Re: S/D 88-36 - EMERY PARK ADDITION

EMERY PARK ADDITION, FINAL PLAT
COMMENTS APPROVED BY S/D COMMITTEE
7/28/88

Re: Preliminary Plat S/D 88-36 - EMERY PARK ADDITION

CASE NUMBER: S/D 88-36 - EMERY PARK ADDITION

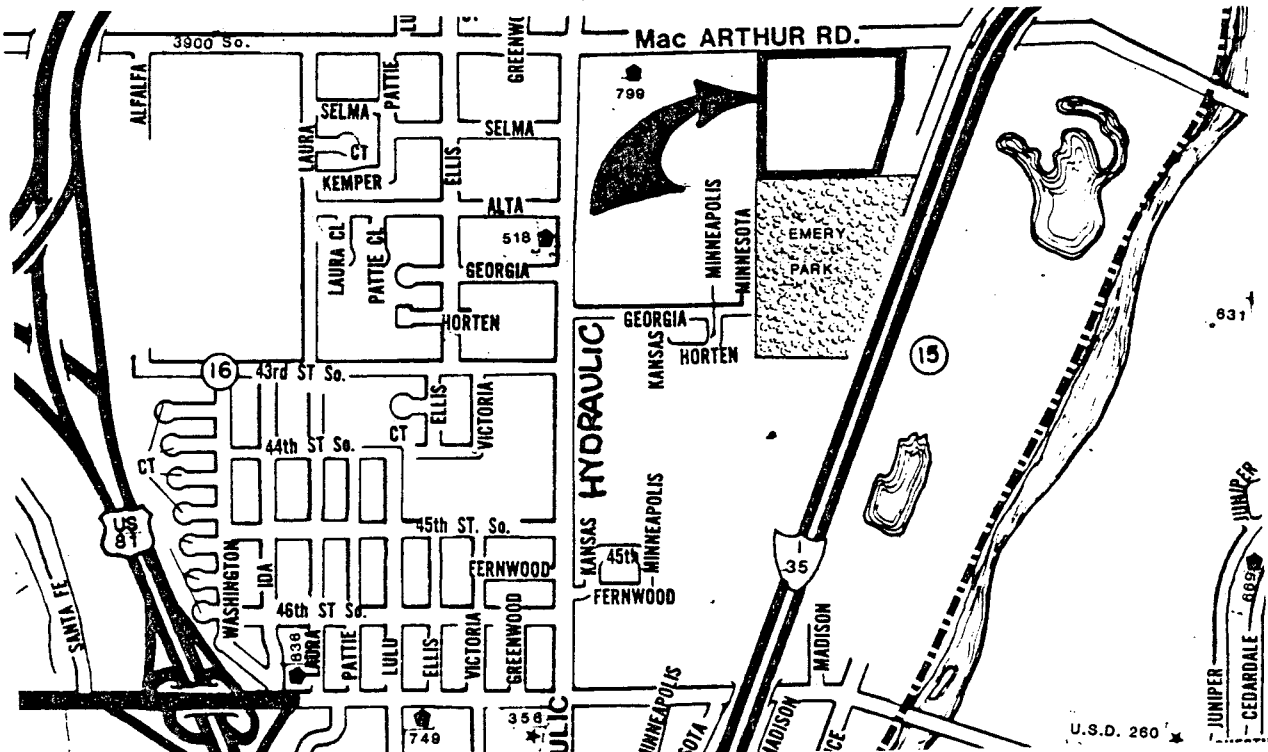
- A. The applicant shall guarantee the extension of City water to serve the lots being platted.
- B. The applicant shall guarantee the extension of sanitary sewer to serve the lots being platted.

- C. The applicant shall guarantee any drainage improvements required by the platting of this property.
- D. The applicant shall guarantee the paving of the proposed interior streets.

- E. For Minnesota, the applicant shall attempt to obtain the off-site street dedication to the west of this plat. The applicant shall guarantee the paving of Minnesota from MacArthur to the south line of this plat. As this street is being platted as a collector street, the paving petition shall provide for a sidewalk on each side of the street. If the street dedication cannot be obtained, it is recommended that the paving petition provide for condemnation costs for the needed right-of-way.

- F. The applicant shall guarantee construction of the storm sewers required by this plat.
- G. If improvements are guaranteed by petition, a notarized certificate listing the petitions shall be submitted to the Planning Department for recording.

- H. The applicant shall submit a covenant which provides for four (4) off-street parking spaces per dwelling unit on each lot which abuts a 58-foot street. The covenant shall inventory the affected lots by lot and block number and shall state that the covenant runs with the land and is binding on future owners and assigns.

- I. It is noted that the applicant is requesting the platting of 20-foot building setbacks for the residential lots, rather than the 25-foot setbacks established by zoning.

- J. For those reserves being platted for drainage purposes, the required covenant which provides for ownership and maintenance of the reserves shall grant, to the City, the authority to maintain the drainage reserves in the event the owner(s) fail to do so. The covenant shall provide for the cost of such maintenance to be charged back to the owner(s) by a method similar to special assessments.

- K. The applicant shall submit a copy of the instrument which establishes the Northwest Central Pipeline easement on this property. The applicant's agent shall determine any setback requirements from the pipeline by researching the text of the pipeline agreement.

- L. Any relocation, lowering or encasement of the pipeline made necessary by this development will not be at the expense of the City.

- M. The final plat shall indicate the recording information for the Northwest Central Pipeline easement on this property.
- N. The applicant's engineer is advised that the Register of Deeds is requiring the name(s) of the notary public, who acknowledges the signatures on this plat, to be printed beneath the notary's signature.

- O. The applicant shall install or guarantee the installation of all utilities and facilities which are applicable and described in Article 8 of the MAPC Subdivision Regulations.

- P. Requirements for a final plat (see pages 20-25, Part 4, Article 5 of the MAPC Subdivision Regulations).
- Q. The representative from City Engineering should be prepared to comment on the status of the applicant's drainage plan.

- R. Perimeter closure computations shall be submitted with the final plat tracing. Section 5-101(C).
- S. Recording of the plat within 30 days after approval by the City Council.

- T. The representative from the City Engineer's office should be prepared to comment on the status of the applicant's drainage plan. Specifically, what drainage guarantees are required and what is the needed elevation for the minimum pad elevation.
